SUBJECT: TRANSMITTAL OF BRIEFING CHARTS TO THE ADVISORY COMMITTEE
ON NUCLEAR WASTE (ACNW) FOR THE DECEMBER 1991 BRIEFING

**STAFF TECHNICAL POSITION ON INVESTIGATIONS TO IDENTIFY
FAULT DISPLACEMENT AND SEISMIC HAZARDS AT A GEOLOGIC
REPOSITORY**

**RESPONSES TO COMMENTS ON THE STAFF TECHNICAL POSITION:
INVESTIGATIONS TO IDENTIFY FAULT DISPLACEMENT AND
SEISMIC HAZARDS AT A GEOLOGIC REPOSITORY**

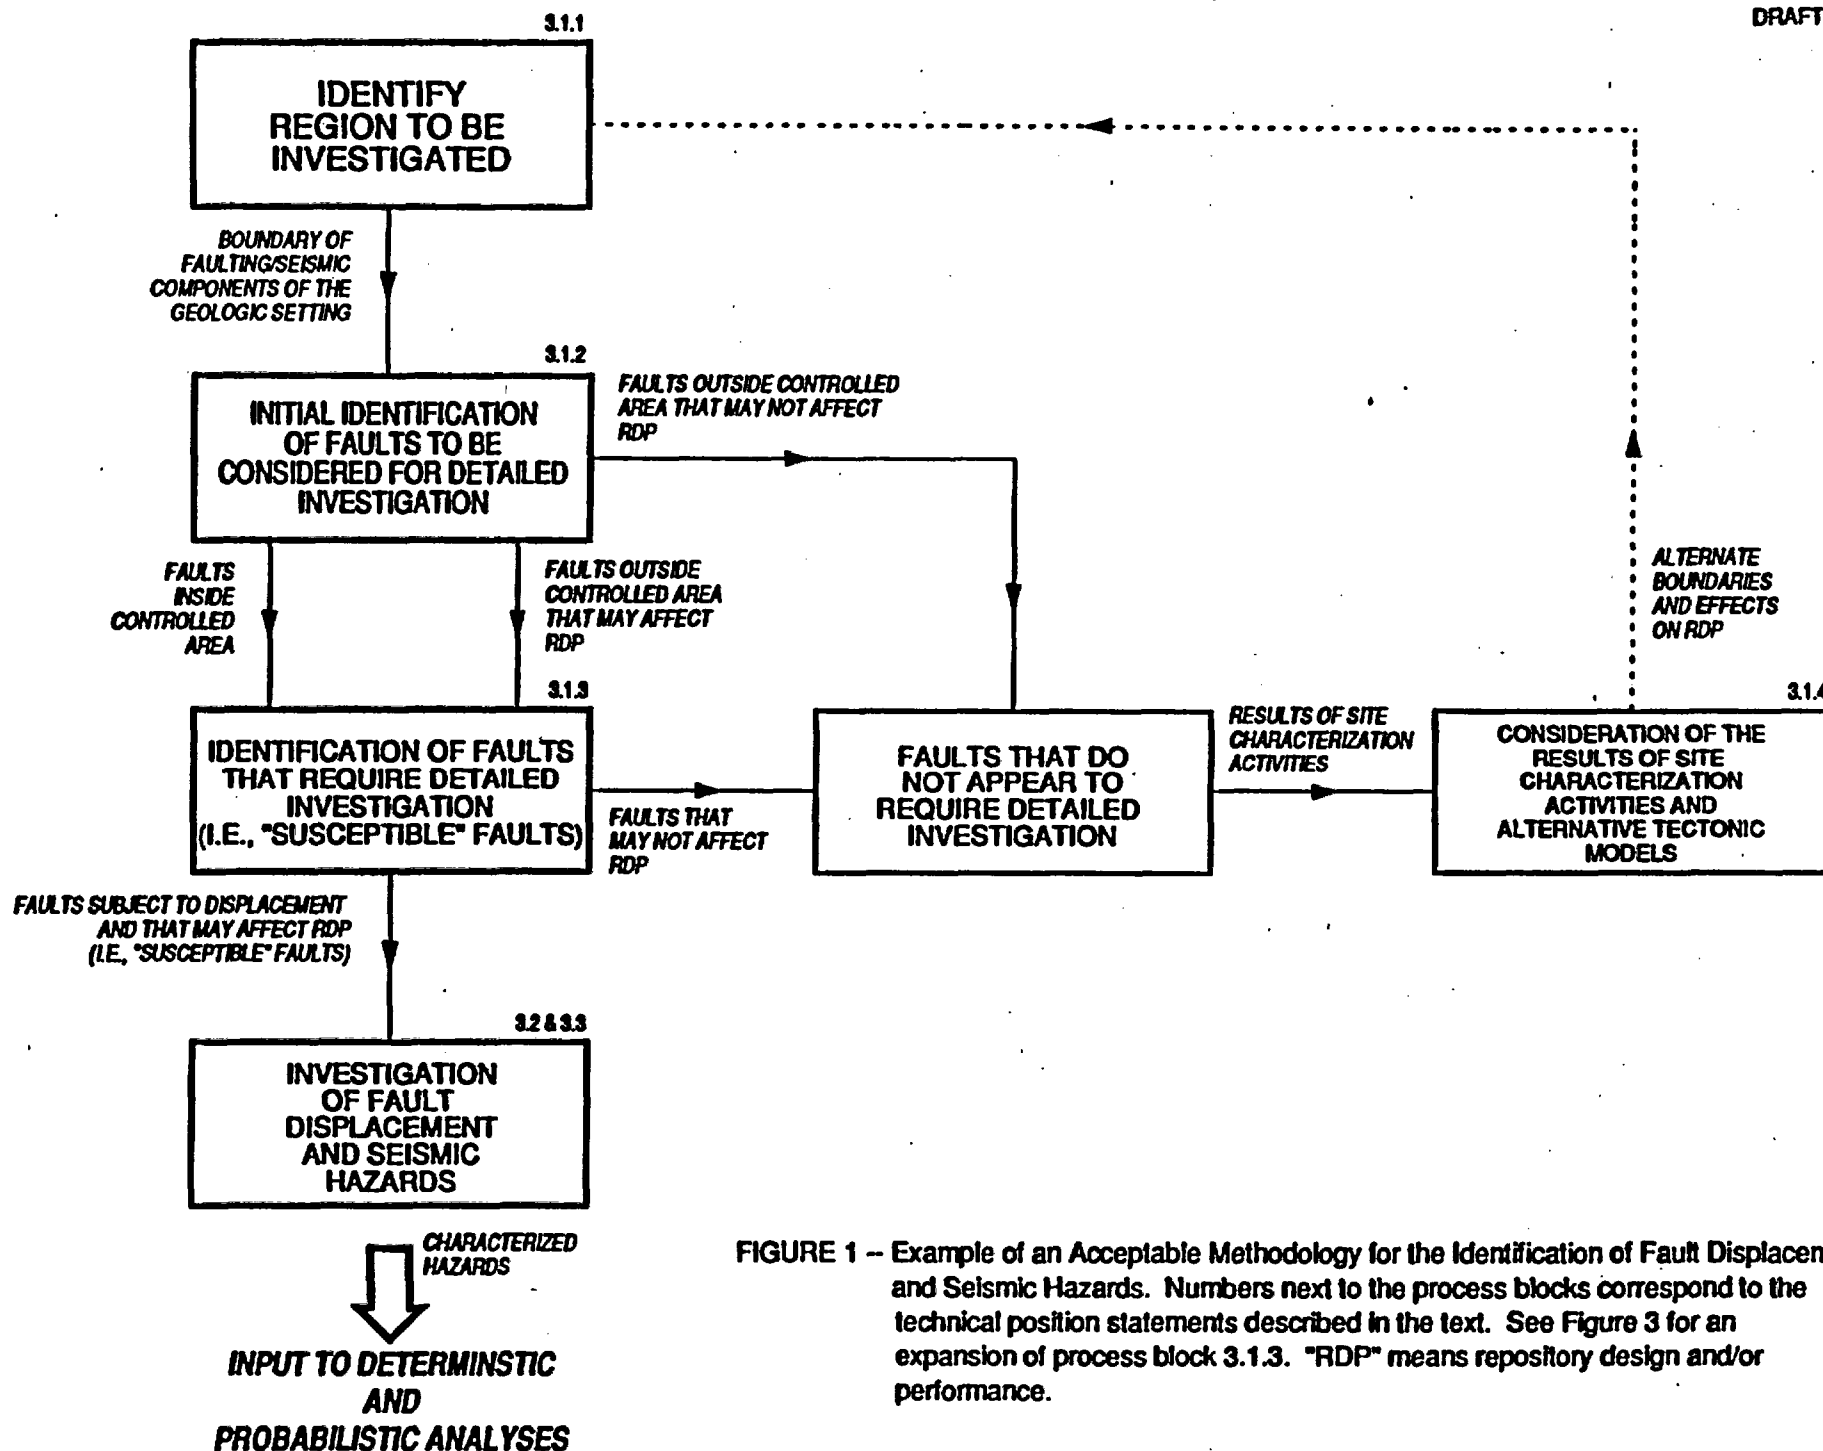
- Disagree with the concept that probabilistic techniques be avoided because they are not sufficiently conservative to identify faults requiring detailed investigation (App. E, AEG comment #4).
- A responsible method of assessment can be accomplished with a probabilistic technique. Empirical relationships form the foundation for a probabilistic approach (App. E, AEG comments #6 and #7).
- The STP rejects, without technical basis, the use of probabilistic techniques in determining which faults require detailed investigation. Appendix A to 10 CFR 100 is likely to endorse a combination of probabilistic and deterministic approaches (App. E, DOE comment #3).
- Combining probabilistic and deterministic approaches to earthquake hazard and design-basis development is most appropriate and is representative of the current state of art (App. E, DOE comment #3).

- **Benefits from past regulatory experience in using explicit criteria for identifying fault and seismic hazards**
- **Outline data necessary to fulfill requirements of 10 CFR 60**
- **Use deterministic criteria to determine which faults require detailed investigation**
- **Permit the removal of criteria from further consideration for the identification of faults subject to displacement if data are inconclusive (with appropriate documentation)**
- **Identify the entire Quaternary record as the period of geologic time that should be considered**
- **Allow for reconsideration of faults eliminated from further consideration if assumptions change.**
- **Recognizes the need to perform iterative assessments of performance and that additional investigations to those noted in the STP may be identified by these assessments.**

FIGURE 3 -- Staff Technical Position 3.1.3: Detail to the "Approach to the Identification of Faults that Require Detailed Investigation (I.e., "susceptible" faults)." Refer to the text for the discussion of this two-step process. Also see Figure 1. "RDP" means repository design and/or performance.

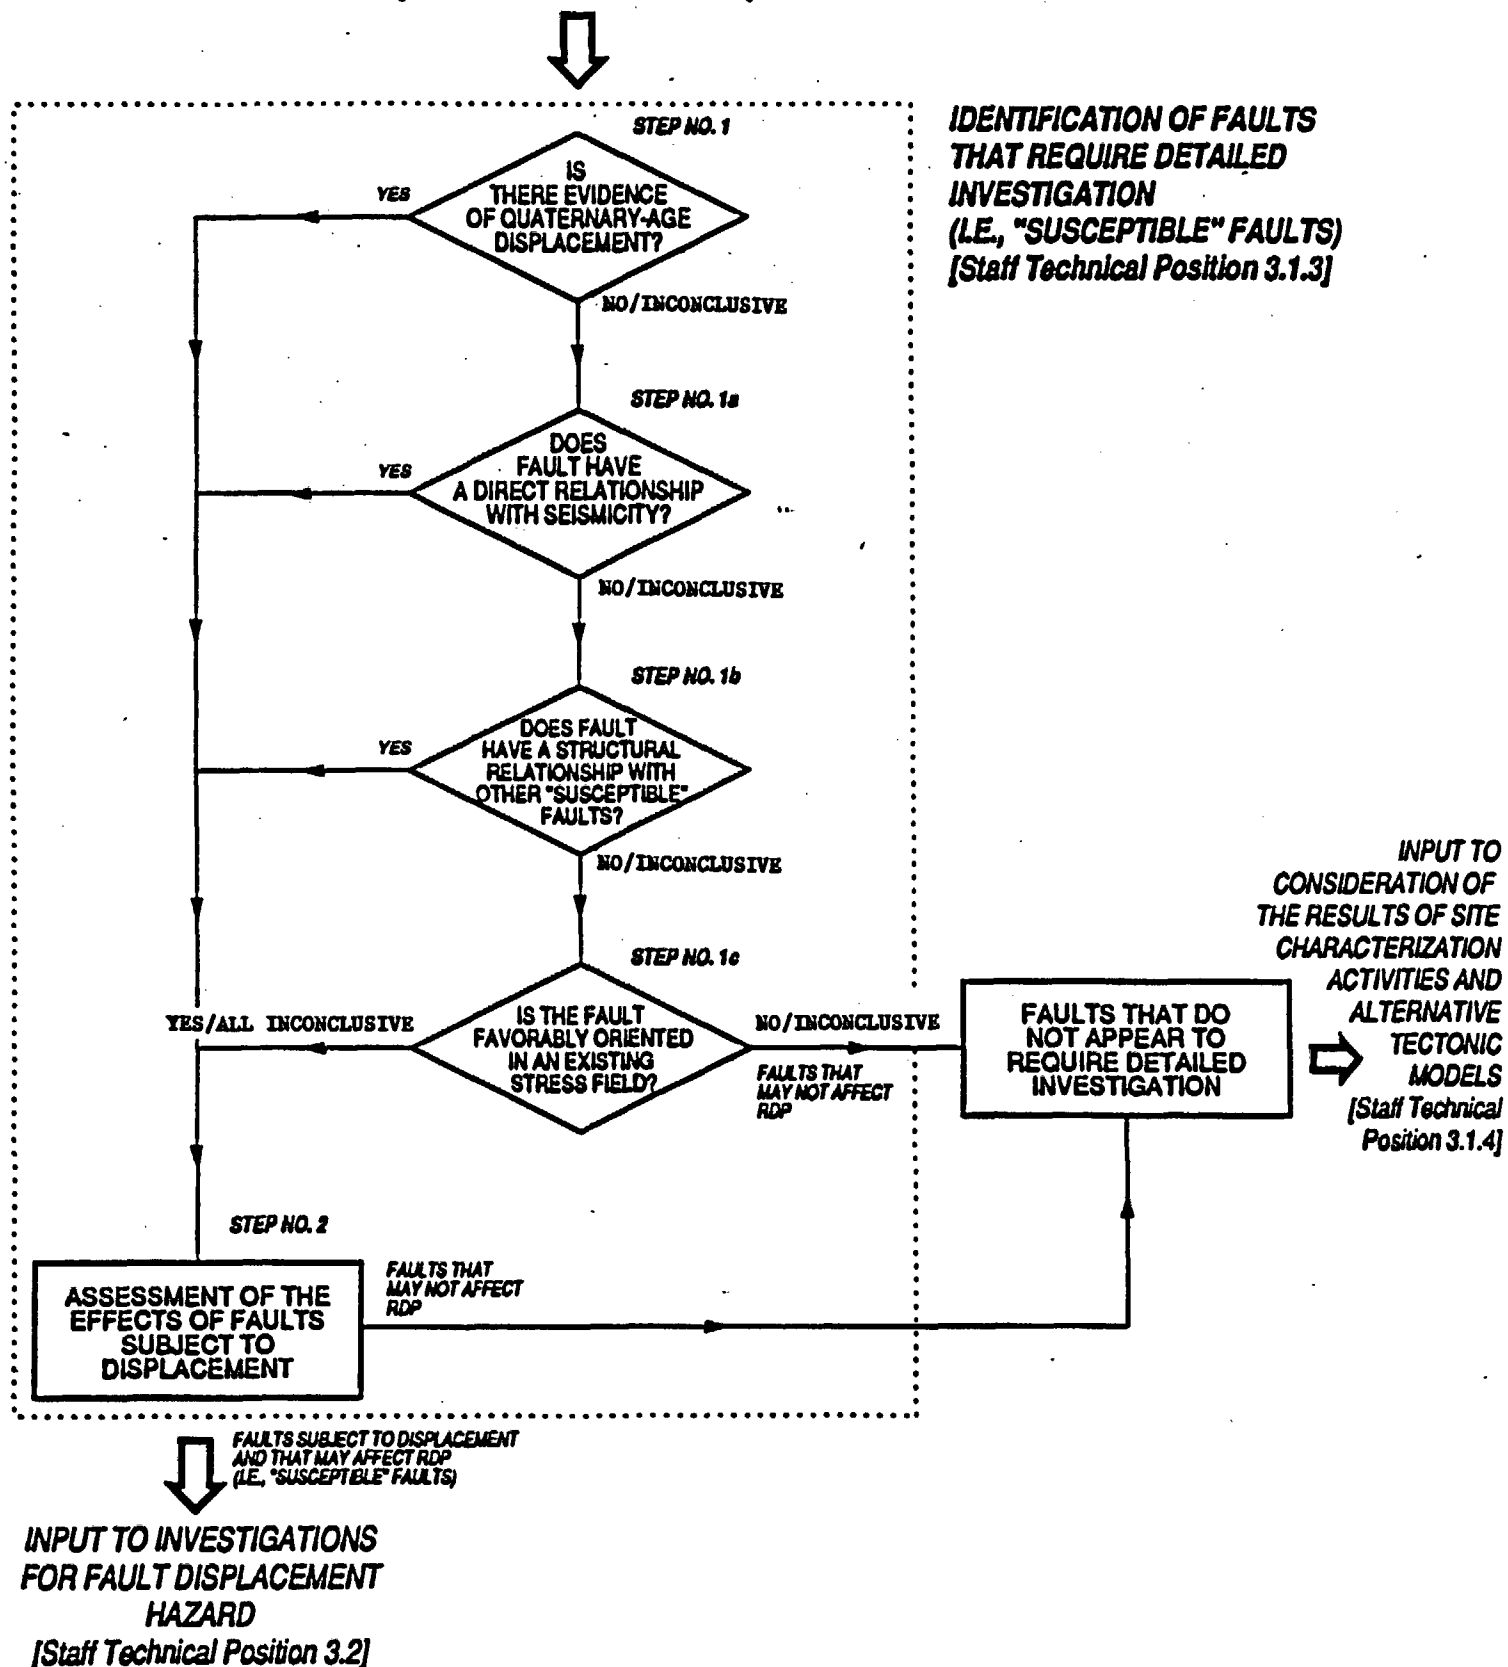
- Uncomfortable with the name "susceptible" fault.
Concerned that unique terminology may be developed for different applications (i.e., nuclear power stations vs. radioactive waste disposal) (App. E, AEG comment #2).
- DOE believes the technical basis for the STP has not been demonstrated. STP appears to suggest that an unacceptable risk would exist if a fault with certain characteristics was not investigated in detail. No technical basis for the approach has been provided (App. E, DOE comment #2).
- The concept of "susceptible" faults has not been reviewed by the geologic community (App. E, DOE comment #6, NEV comment #3).
- The use of the term "susceptible fault" is vague, prejudicial, and misleading (App. E, EEI/UWASTE).

DEFINITION OF SUSCEPTIBLE FAULT

A Susceptible fault is a fault that:

- 1) is subject to displacement; and**
- 2) affects the design or performance of structures, systems, and components important to safety, containment, or waste isolation; and/or**
- 3) will provide data for significant input to models used in assessments of design or performance of structures, systems, and components important to safety, containment, or waste isolation**
